From: Mann, Ryan
To: [Yu, Olivia, EMNRD](#); [LovelyTaylor, Kayla](#); [Martin, Ed](#)
Cc: [Goates, R. Neal](#); [Pope, Gregory](#); [Wells, Todd](#)
Subject: RE: 1RP-4593 Excavation complete and requesting backfill approval
Date: Thursday, July 5, 2018 9:56:45 AM
Attachments: image002.png
image003.png

From: LovelyTaylor, Kayla <Kayla.LovelyTaylor@tetratech.com>
Sent: Tuesday, July 3, 2018 2:39 PM
To: Yu, Olivia, EMNRD <Olivia.Yu@state.nm.us>; Martin, Ed <emartin@slo.state.nm.us>; Mann, Ryan <rmann@slo.state.nm.us>
Cc: Goates, R. Neal <N.Goates@conocophillips.com>; Pope, Gregory <Greg.Pope@tetratech.com>; Wells, Todd <Todd.Wells@tetratech.com>
Subject: 1RP-4593 Excavation complete and requesting backfill approval

ConocoPhillips	
Figure 4	
EVGSAU 2923 - 001 (32.807067, -103.475858)	
Excavation Area & Depth Map	
Lea County, New Mexico	
Project: 212C-MD-00939	
Date: 12/15/2017	
File: H:\GIS\212C-MD-00939

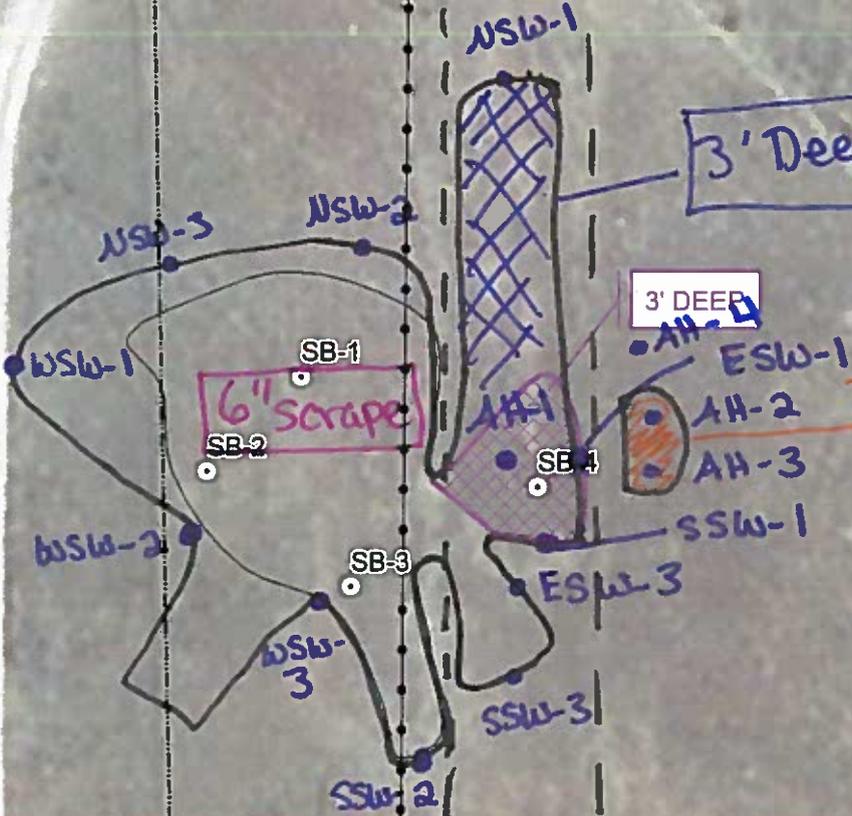
Tetra Tech is working towards lining, backfilling, and re-vegetating according the approved work plan. Attached is a hand drawn map depicting the spill footprint and sample locations. Please review and let me know if it is acceptable to proceed forward.

Please be advised that all scaled maps must include the release point, in relation to delineation sample locations.

NMSLO also approve backfill.

Thank you for the update and addressal of the historic release. NMOCD grants backfill approval for 1RP-4593 and the historic impacted area. Please ensure that laboratory analyses for confirmation sidewall samples and bottom samples for the historic release area are within permissible levels and identified clearly in the closure report.
